General Comments

## Article 2 Public Comments

FIGURE 8.01

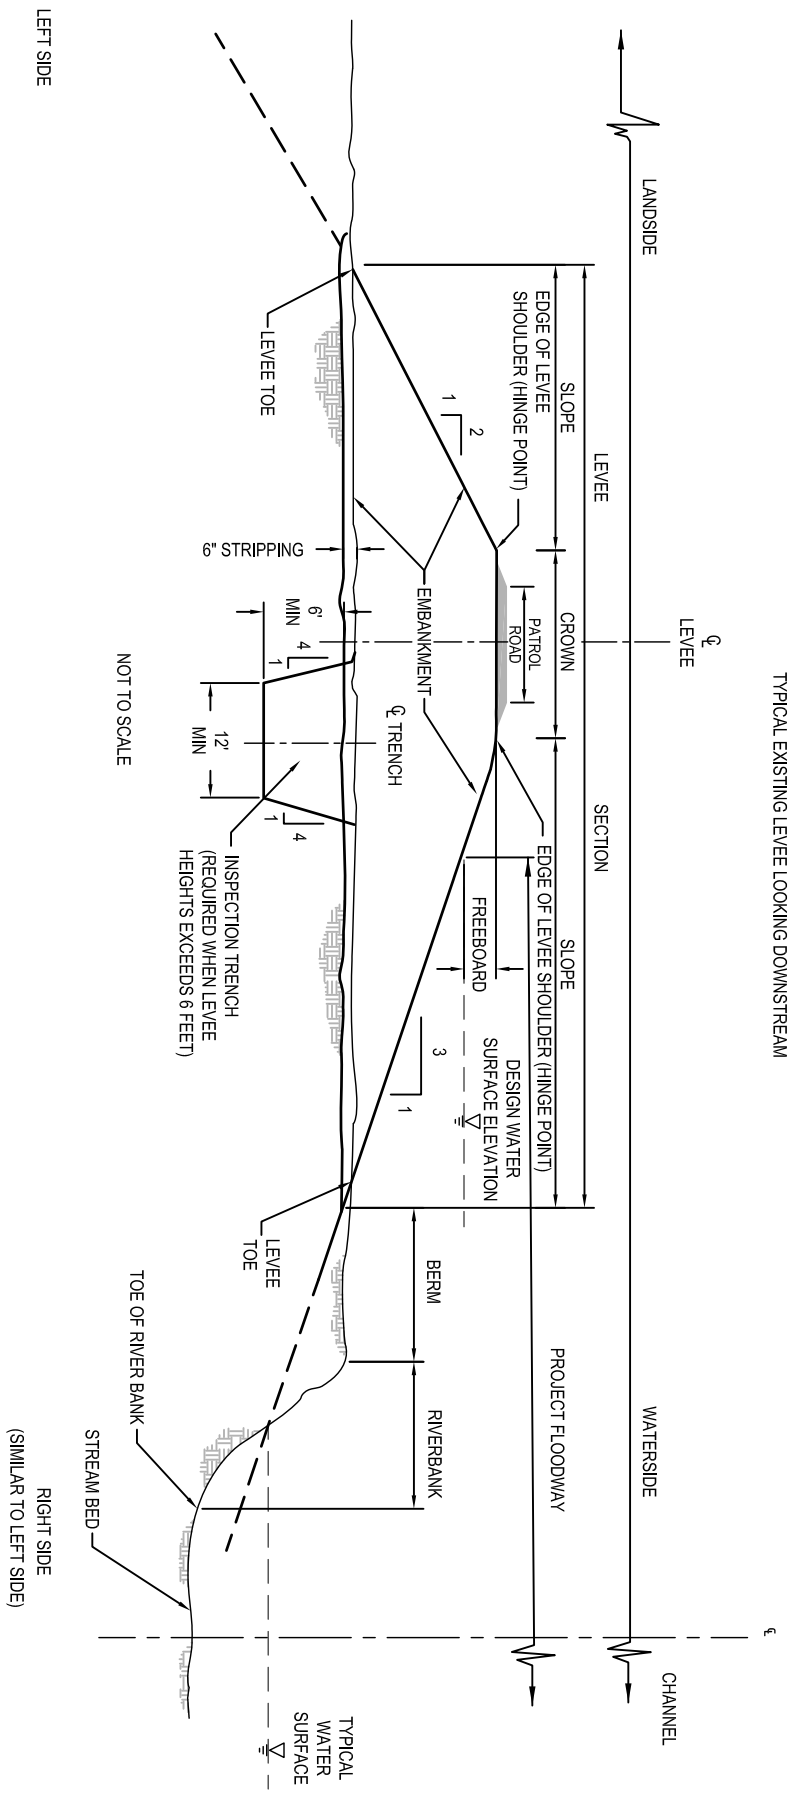
Section 113 - Dwelling and Structures Within APFC	d(2)	DCCEng.	(d) (1) is hard to follow and would be helped by Figure 8.1a please include in the next draft.	Comment originally submitted for (d)(1). This comment appears to apply to Section 113(d)(2). Figure 8.1 is now included.
Section 113 - Dwelling and Structures Within APFC	d(2)	KSN	Does not appear to differentiate between existing or new, so does this make existing structures subject to requirements?	This applies to new and/or unpermitted Dwellings, Dwellings for seasonal occupancy, Buildings, and Mobilehomes.
Section 113 - Dwelling and Structures Within APFC	b(3)(B)	MSCE	Notice Article 8, Section 113, (b)(3)(B) calling for the floor of a new home to be 3' above the 200-yr floodplain. In the flatter areas this will require significant additional fill or raised foundations.	The Board Standards have been revised for clarity, requiring a minimum elevation of two (2) feet above the Design Water Surface Elevation.

FIGURE 8.05

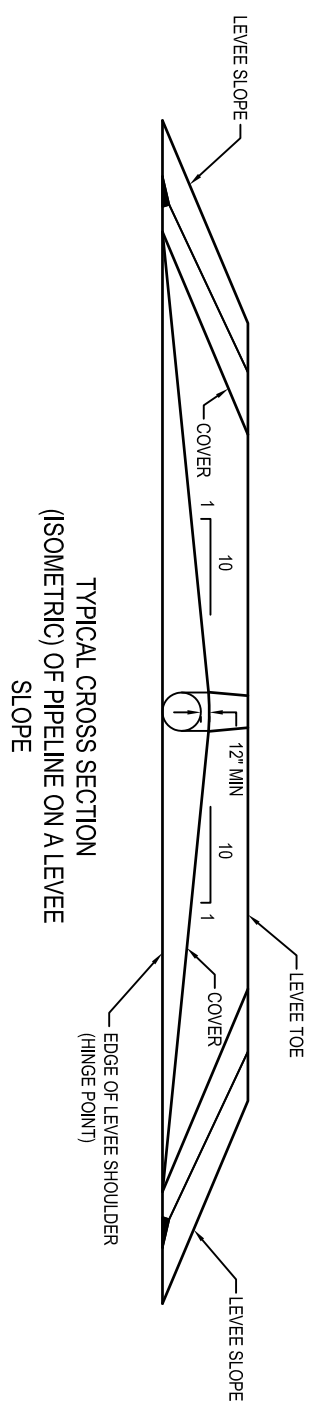
Section 123 - Pipelines, Conduits, and Utility Lines	b(4)	DWR	What about gas lines 20 feet deep, will there be a layer for design levee prism? How do you calculate levee prism?	Though many existing gas pipelines may be located below the Levee Crown, new gas pipelines will need to be located above the Levee crown, consistent with USACE guidance.
Section 123 - Pipelines, Conduits, and Utility Lines	b(4)	DWR	Define levee prism, how to calculate?	This section has been revised consistent with USACE guidance to require the invert of the pipeline to be placed over the Levee crown, with limited exceptions provided in (d)(5).
Section 123 - Pipelines, Conduits, and Utility Lines	b(5)	USACE	To prevent contradictions with par. 123(b)(4), it should be clearly indicated that the minimum cover at the levee crest should be 24 inches.	This section has been revised to address this comment. See (d)(9) and (d)(10). A new Figure 8.05 is included for clarification.
